814 Thayer Ave, Limited Site Plan Amendment, 82008007A

Completed: 5.18.12

- 814 Thayer Avenue, Silver Spring
- 0.64 acres in the CBD-0.5 zone
- Silver Spring CBD Sector Plan
- Requesting changes to the affordable housing component, building design, and to public use space and public amenities.
- Applicant: Residences at Thayer, LLC
- Application submitted: January 12, 2012

Staff Recommendation: Approval with conditions

Thayer Avenue Elevation of Proposed Plan Amendment (plaza and sidewalk in front of building do not reflect current design; the remaining utility pole would be located adjacent to the right-most street tree)

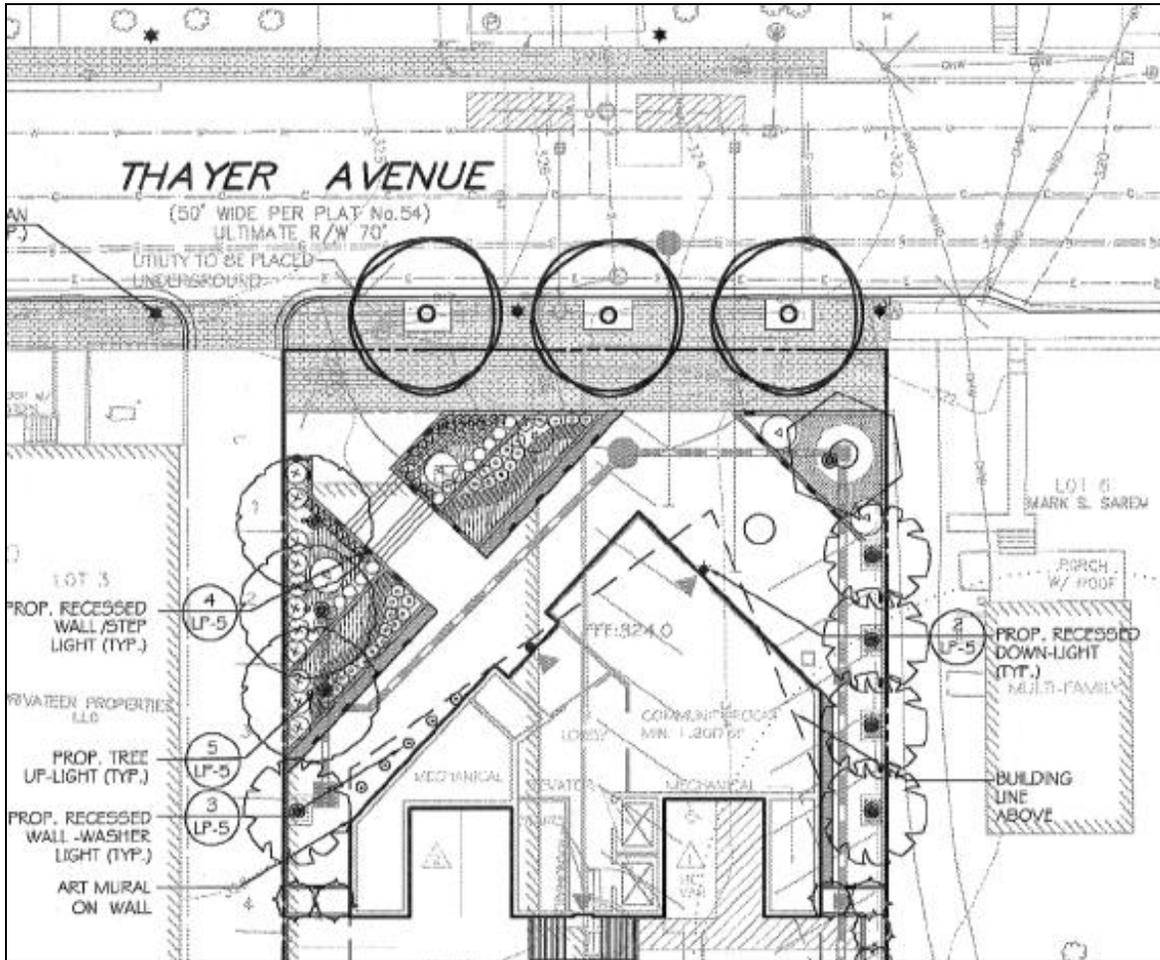
While the total number of units (52 du), building height (60'), parking, loading, and service remain unchanged, the applicant has hired a new architect to redesign the building. The Thayer Avenue building elevation, under the approved design, featured asymmetrical building floors alternating in a "scissor" fashion. The revised Thayer Avenue elevation simplifies the design with a single diagonal slanting back into the site from the northeast corner of the site.

Approved Landscape Plan, Paving Detail

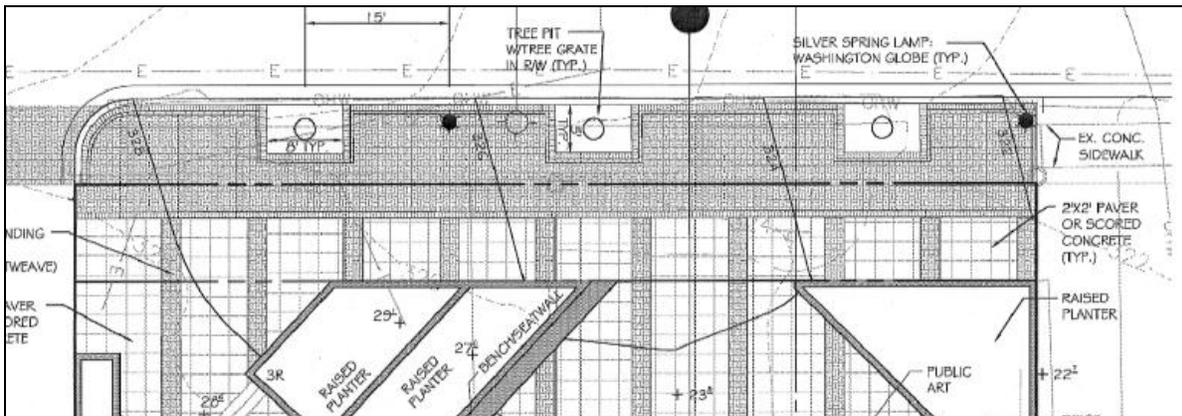
The applicant has redesigned the public use space in front of the building. The previously approved design (below) has a sunken courtyard accessed by steps from the sidewalk, with planting beds, seat walls, and public art. The approved design covers 22.5 percent of the net lot area.
